**MEMORANDUM**

**TO:** District of Columbia Board of Zoning Adjustment  
**FROM:** Stephen Cochran, Project Manager  
*JL* Joel Lawson, Associate Director Development Review  
**DATE:** January 31, 2020  
**SUBJECT:** BZA Case 20196 - Special Exceptions to allow a rear deck addition to an existing rowhouse at 220 Ascot Place, NE

Proposed Deck

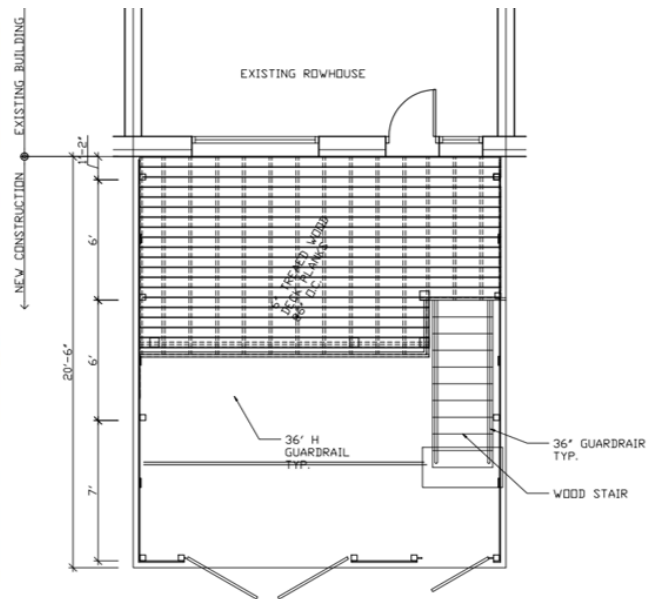
The recently-demolished deck on the applicant's property was 6 feet deep and semi-enclosed with an awning and transparent roll-down curtains. Many properties facing the alley have decks or rear additions ranging from 6 feet to 10 feet deep. Given this pattern and the size of the proposed deck – which would not have an awning or temporary enclosure, it is not likely to have an undue effect on the north-facing rear yards or rooms of the adjacent rowhouses.

While there could be some impact on the privacy of use of adjacent rear yards, the impact would not likely to be greater than any of the other nearby rear decks and should not be undue. The views from the proposed deck would be similar to what had existed prior to the demolition of the metal deck. exists today. The level of privacy of use and enjoyment of neighboring properties that currently exists should not be significantly reduced by the proposed addition.

The two-story proposed addition would be located at the rear of the subject property and would not be visible from a public street. Many of the rowhouses that abut the rear alley have similar rear decks or additions. As such, the proposal should not visually intrude upon the character, scale, and pattern of the rowhouses as seen from the street or the alley.
